CDDFRS
Peterlee Fire Station

Tender Queries & Addendum Tracker

Tender Date: 26/06/24
Query Deadline: 17/07/24
Tender Return: **25/07/24**

Revision Date: **08/07/24**

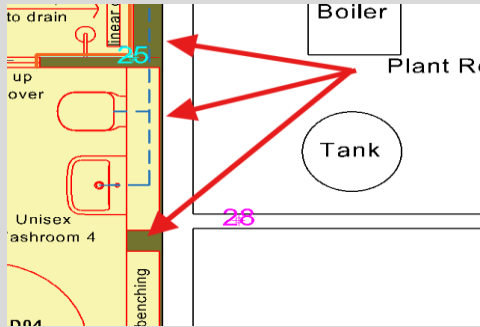
No.	Date	Query	Response/ Addendum
1	26/06/24	<p>Please can you confirm if the areas pointed to below require wall linings:</p> 	Yes, wall linings are required to these areas
2	26/06/24	<p>Can you confirm Altro Aquarius 'Walrus' Vinyl flooring is to be used throughout for all new floor areas including the showers as well as a requirement for coved skirting to all areas throughout</p>	Yes, to all areas hatched yellow on the plan
3	27/06/24	<p>It appears the drawings ask for the same vinyl on the shower room walls as is specified on the floors assuming this is a mistake please can you confirm if an internal wall cladding is to be used instead</p>	The internal wall lining to the showers has been updated to Polyclad Pro PU 'Grey Steel', please find attached updated Proposed Plan rev4.
4	02/07/24	<p>The shower area wall finishing spec is 'Altro Aquarius Walrus' Vinyl; Is this correct or would you like us to price for a wet room wall cladding system, like a Altro Whiterock?</p>	Refer to Query 3 response above.
